37/3-02BB 25 Holt Place (Takoma Park Historic District)

SUBJECT: Historic Area Work Permit

### **HISTORIC PRESERVATION COMMISSION STAFF REPORT**

Reconstruct front porch to accommodate basement storage area under the porch. Replace existing lattice with stuccoed masonry. Reconstruct new basement steps with metal railing. Reconstruct 2<sup>nd</sup> story porch railing. Replace existing vinyl window with wood

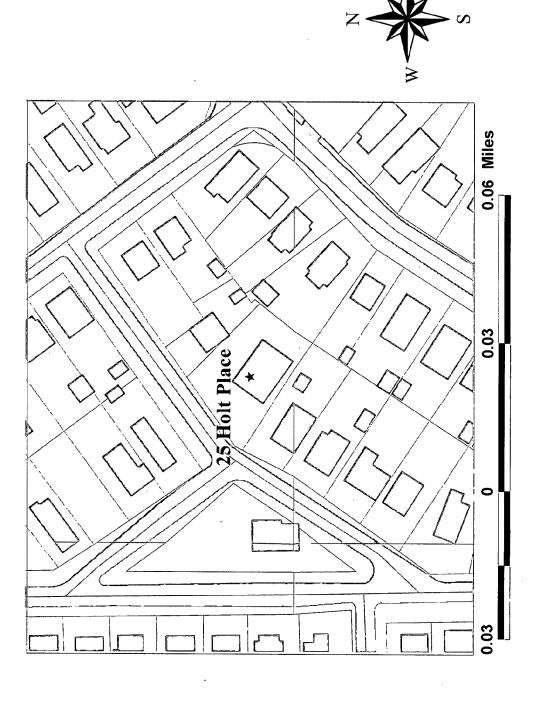
Staff has no concern with the use of either a metal or wood rail for the new basement steps. This element will clearly be a secondary element on the house. Perhaps the basement step railing should be painted as a foundation element, however, to draw less attention to it, but this is should be the applicant's choice.

Staff is concerned with the proposed use of the plastic wood flooring for the porch. While the material will be painted, the 3-1/8" width is typically wider than historic strip flooring. In addition, staff is concerned that the appearance of the wood will be so regular as to appear artificial. If the applicant constructs the storage room with a weathertight roof, wood strip flooring can be installed on spacers to provide the necessary ventilation under the wood floor.

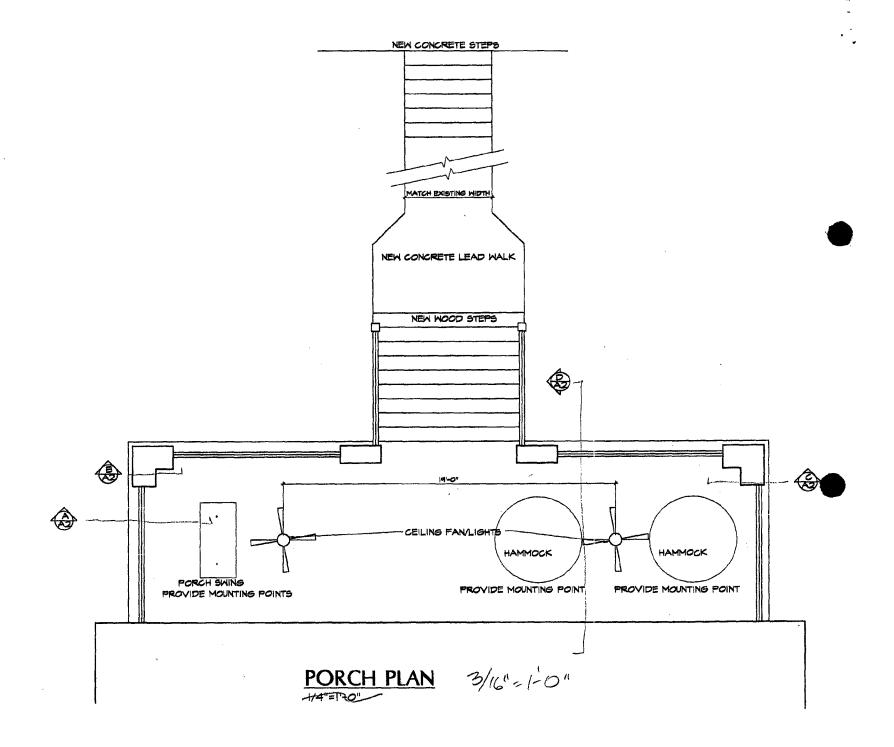
The applicants wish to restore the  $2^{nd}$  floor railing at the porch as part of this project. Two alternatives are shown (see Circle (3, 14)). Neither proposal matches the historic photographs. Proposal A would use straight posts and straight pickets, but with no direct relationship of  $2^{nd}$  story post to  $1^{st}$  floor column. Proposal B would use the starburst pattern for the pickets, but incorporated paired boxed posts set above the paired columns on the first floor.

The 1935 photograph shows the house with turned posts at the  $2^{nd}$  floor level (two of which remain in situ adjacent to the house – see Circle 23), and twin boxed columns at the first floor level. The posts are lined up from floor to floor, and work within an established hierarchy of doubled columns for strength on the first floor, with lighter single columns set directly above (see Circle 1/6). The starburst pattern of railing at the  $2^{nd}$  floor is quite distinct from the straight picket railing at the first floor level.

In the 1985 photograph, the 2<sup>nd</sup> floor railing has been changed to a straight picket and straight post style to match the 1<sup>st</sup> floor porch below. There is one post at the 2<sup>nd</sup> floor to match the doubled columns below on the 1<sup>st</sup> floor, conforming with the original design hierarchy.

Staff feels that neither of the applicant's proposals achieve restoration of the 2<sup>nd</sup> floor railing. Proposal A would be fine if the posts were installed as single posts only and the spacing were adjusted to match the paired columns below. This would be a match to the 1985 photograph. On the other hand, proposal B would be a match to the 1935 photograph if there were single turned columns set above the paired columns below. Staff would recommend approval of either of these modified proposals which would match the historic photographs. Since the original turned columns were retained in the recent renovation project at this site, staff would lean towards recommending the use of the turned post to match the original posts. This will help recall the earlier Italianate style of the house, which has been modified with the Revival style porch columns and pickets at the 1<sup>st</sup> floor level.

- 1. Redesign the 2<sup>nd</sup> story porch railing to reflect the historic photographs. Either use a single turned post as per existing originals, or use a single boxed post. Details to be worked out at staff level.
- 2. The new wood window will be true-divided light or simulated TDL with muntins on the interior and exterior of the glass sandwich.
- 3. The applicant to provide a sample of the Tendura flooring to the HPC, as well as more detailed information about the existing porch floor. Staff recommends use of this material only if it matches exactly the historic wood flooring in terms of width, appearance, character and feel.
